ELECTRICAL—HEAVY STATIC OR SIGNAL LOSS ON TWO WAY RADIO COMMUNICATION—BI-FUEL LPG VEHICLES ONLY

Article No. 02-21-5

FORD: 2001-2002 F-150

Figure 1 - Article 02-21-5

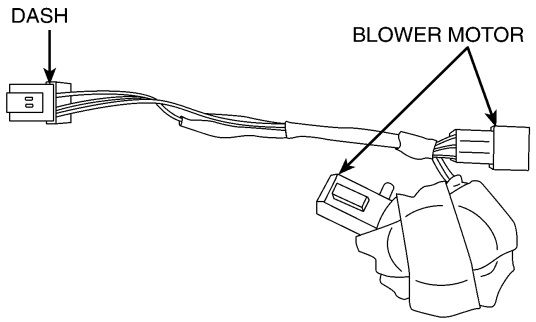
Some 2001-2002 Bi-Fuel F-150's may exhibit heavy static and possible loss of signal on customer installed two-way radios operating in the range of 47 MHz. Operation of HVAC blower motor and windshield wipers may increase severity of symptoms. This may be caused by the Compuvalve and Blower Motor Harness.

1. Replace the Compuvalve 2L3Z-9F954-AE. Refer to Section 303-04D in Workshop Manual.
2. Replace HVAC blower harness 3L3Z-18B574-AA (Figure 1).
   a. Remove connector from blower motor behind dash, right hand side of vehicle.
   b. Unplug the two connectors and remove short (8 inch) harness containing the blower connector.
   c. Install blower connector to blower motor.
   d. Reconnect remaining two connectors.

Install a replacement Compuvalve and a replacement HVAC blower motor harness. Refer to the following Service Procedure for details.
